DS #: 4725

PROJECT: Solano Springs by Richmond American Homes

CITY OF LAS VEGAS		DATE:
INTER-OFFICE MEMORANDUM		April 20, 2015
TO: Land Development Services Department of Building & Safety		FROM: Albert Sung, P.E. Flood Control Project Engineer Department of Public Works
SUBJECT:	Drainage Study for:	
	Solano Springs by Richmond American Homes	
Cross Streets:	SEC of Deer Springs Way & Tee Pee Lane	COPIES TO:
File Number:	F:\Depot\DSMemos\DS4725B.doc	Advantage Civil Design Group
Parcel Number:	125-19-701-018	Richmond American Homes Nevada
Zoning Action:	TMP-56664; SDR-56663; WVR-56662 & MOD-56661	Bart Anderson, P.E., DevCo
FEMA Flood Zone	YES	NO X
Proposed Storm Drain	YES	NO X

**ADDENDUM #1 TO THE
TECHNICAL DRAINAGE STUDY
FOR
SOLANO SPRINGS BY RICHMOND
AMERICAN HOMES**

K PERIMETER SECTION

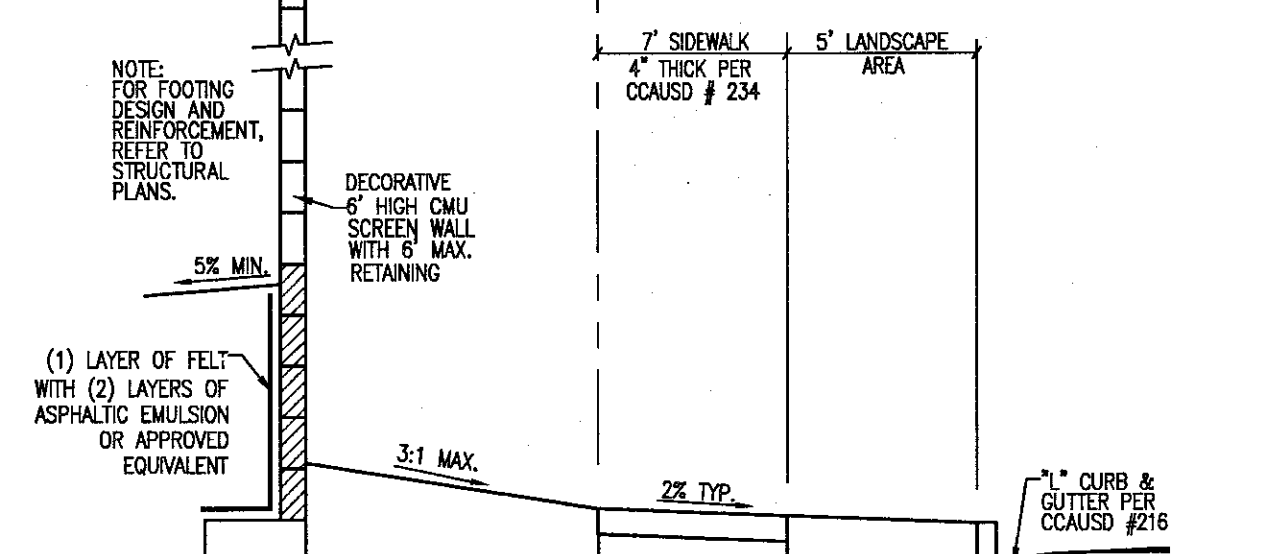
Comment 3: Detail Sections H/DE1, K/DE1, L/DE1 and M/DE1: Clearly specify the 3-course solid grouted blocks above the adjacent grade must be "8"-CMU" or equivalent.

Response 3: A minimum 8"-CMU solid grouted has been added to the plans.

GRADING PLAN 1
SOLANO SPRINGS
RICHMOND AMERICAN HOMES OF NEVADA

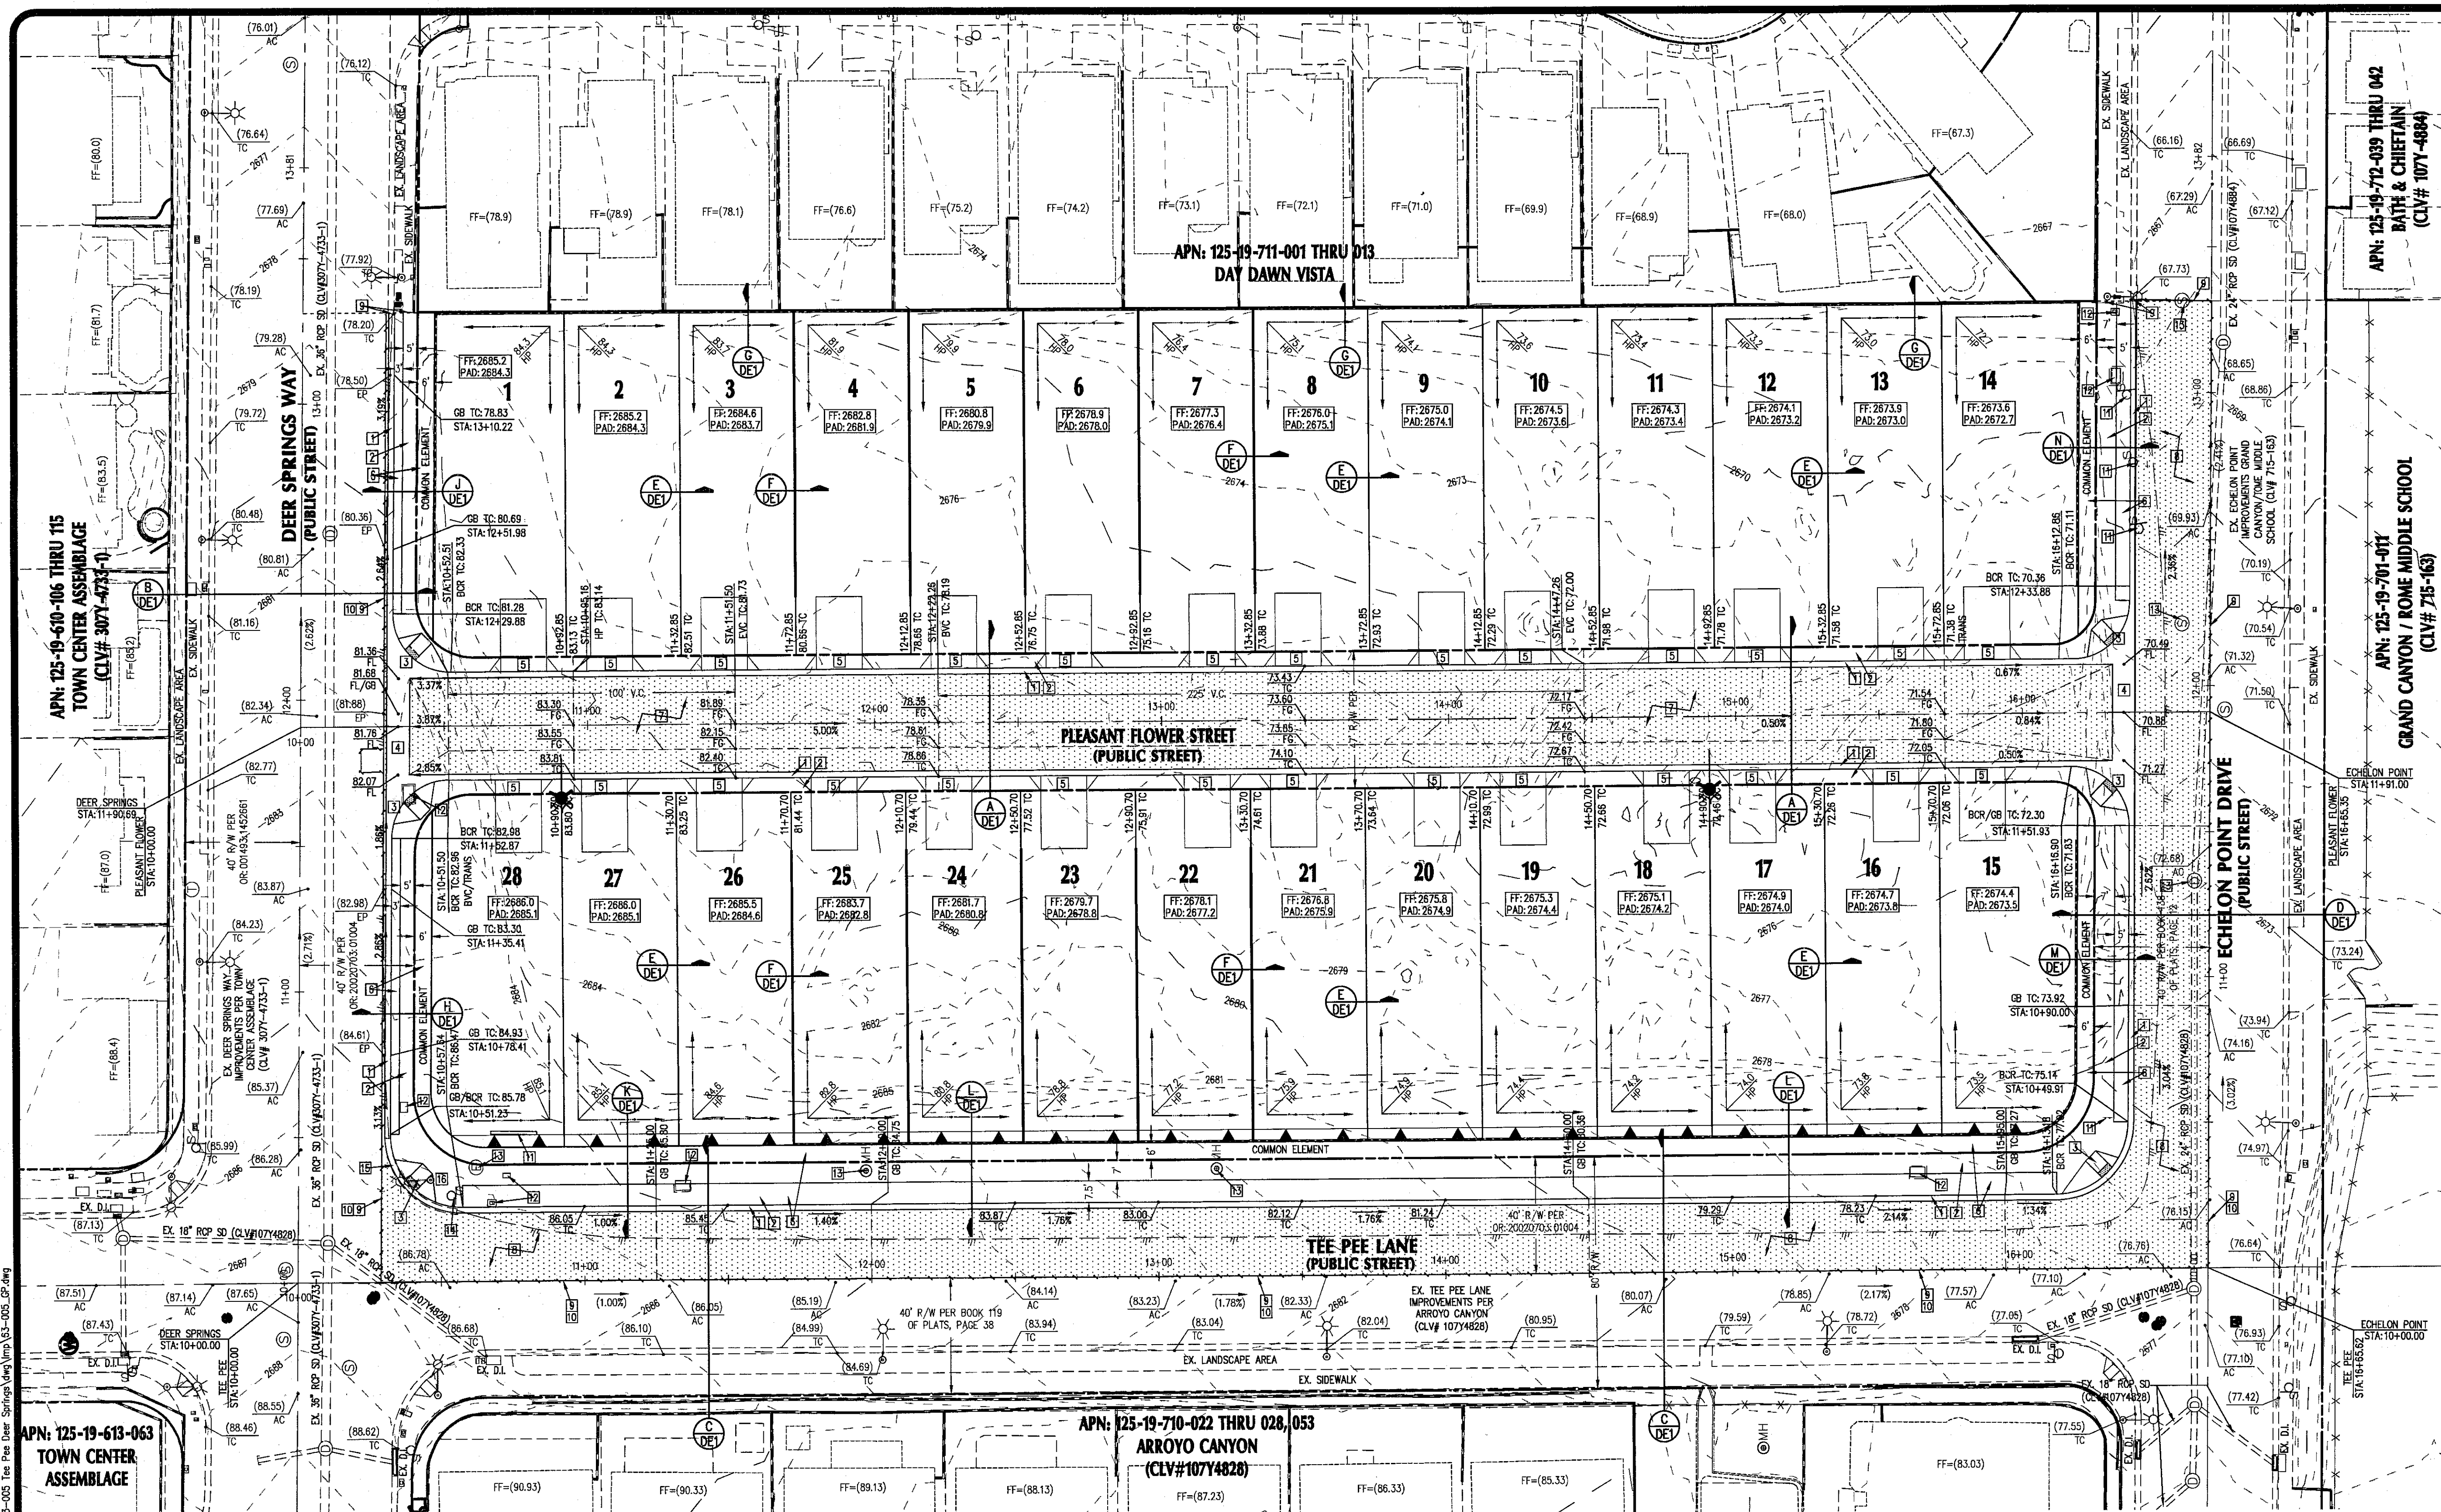
- Note that offset crown street (***Pleasant Flower Street***) is a deviation from standard. Apply for a deviation meeting with *City Land Development Section* for approval prior to the final acceptance of the improvement plans.
- Provide a nominal drop inlet and storm drain lateral at the east end of *Echelon Point Drive* to collect nuisance flow from the proposed development. Revise the grading plan and the pertinent plan & profile sheet accordingly.

PLAN & PROFILE - ECHELON POINT

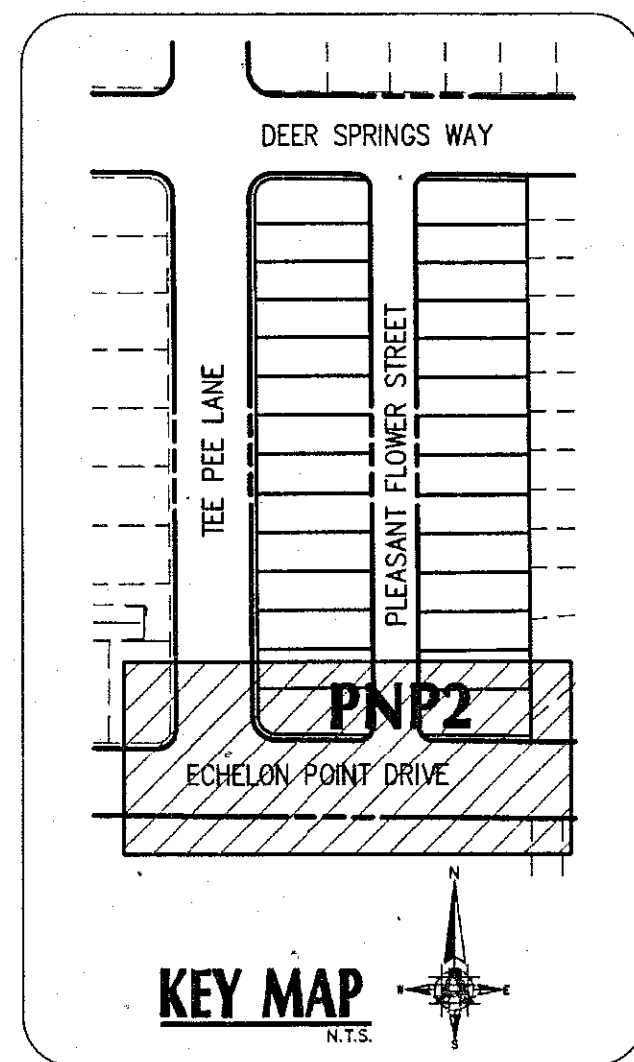
Comment 2: Provide preliminary plan and profile sheets for all proposed public streets (Deer Springs Way, Tee Pee Lane, Echelon Point Drive and Pleasant Flower Street). Plan and profile sheets must show existing and proposed grade at centerline, but may be preliminary in all other respects. These plans are necessary to determine the effect of the proposed development on the adjacent properties.

Response 2: Preliminary plan and profile sheets meet all the requirements listed in Standard Form 2 and should therefore be sufficient for the drainage study review.
